RBG-47382

SUBJECT: License Amendment Request 2013-13  
Heavy Load Movement Over Fuel Assemblies  
River Bend Station – Unit 1  
Docket No. 50-458  
License No. NPF-47

Evaluation of Proposed Changes

**GATE IN LIFTED POSITION IN SPENT FUEL POOL (Looking North)**

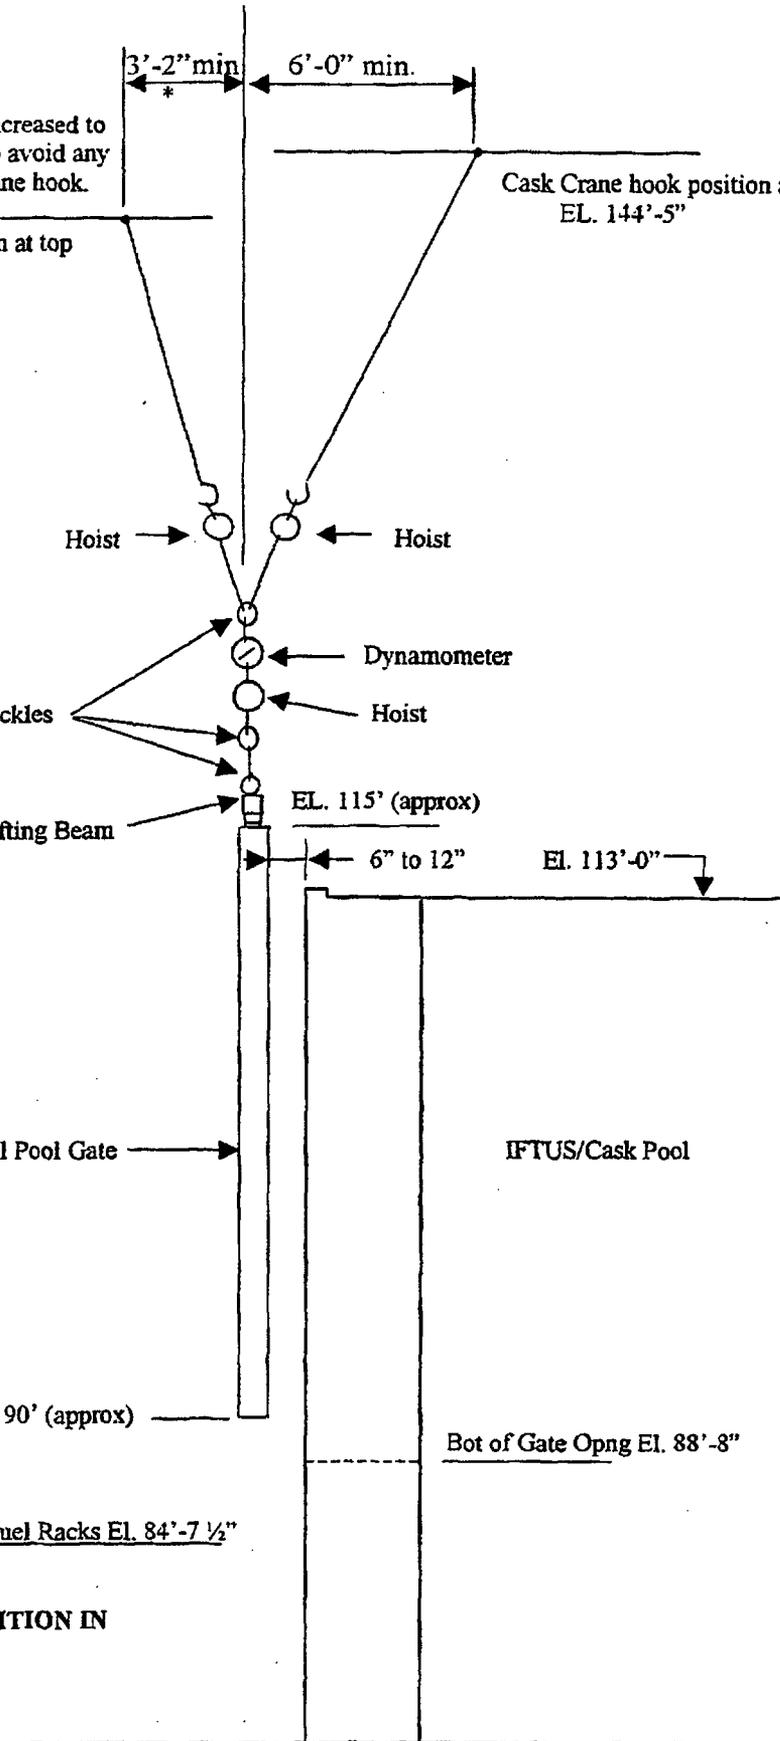
- a. Select all of the rigging equipment (slings, chains, hoists, shackles, etc.) for a minimum rated capacity of 5 tons.
- b. Connect the rigging equipment to the lugs on the lifting beam and to the fuel building crane (MHF-CRN1) 15-ton hook and the fuel building cask crane (MHF-CRN2) 15-ton hook. Attachment 4 contains a sketch of the rigging assembly.

prevent failure of the rigging components, additional redundancy is provided by using redundant load carrying slings and shackles (i.e. doubling each load carrying member of the rigging assembly shown in sketch). The transfer pool gate (FNS-GATE1) will be rigged first. The gate will be initially lifted approximately 12 inches to clear the hinges by applying no more than 3700 pounds in order to overcome friction force. The load will be distributed between the two cranes. The 3700-pound break away load is acceptable as the load is distributed between two cranes. Additionally in the unlikely event of a single failure of one crane, the load at this location could not adversely impact spent fuel. The gate is then moved westward into the spent fuel pool 6 to 12 inches away from the east wall. The gate will then travel a maximum of 11 feet horizontally, parallel to the east wall, by moving both the cranes simultaneously.

If the holding mechanism of the auxiliary hook of the cask crane fails, the gate will swing and finally rest under the bridge crane hook. Considering the worst case initial inclination of the bridge crane hook, the final location of the bottom of the gate will be lowered by no more than 1.5 feet, to an approximate elevation of 88'-6", which is 3'-10" above the top of the fuel racks at elevation 84'-7".

If the holding mechanism of the bridge crane fails, the gate will drop approximately 10" and swing under the auxiliary hook of the cask crane when the gate is aligned to clear the gate opening on the fuel pool wall. However if the holding mechanism failure occurs prior to gate alignment with wall opening, the gate will swing and impact the east wall of the spent fuel pool before its final resting position. Because of the inclination of the crane hook, there will be a horizontal component of the restraining force acting at top of the gate that will tend to move the gate under the hook. The gate will travel a maximum of 12" horizontal before initial impact that is likely to occur near the top of the 4" pool wall curb. The pool curb has a 6" high 1/2" thick continuous plate on the pool side of the curb. Also there is a 1/2" thick plate on top of the curb and a 4"x3"x1/4" angle on the back side. As such the applied impact load will not adversely affect the structural integrity of the pool wall. The capacity of
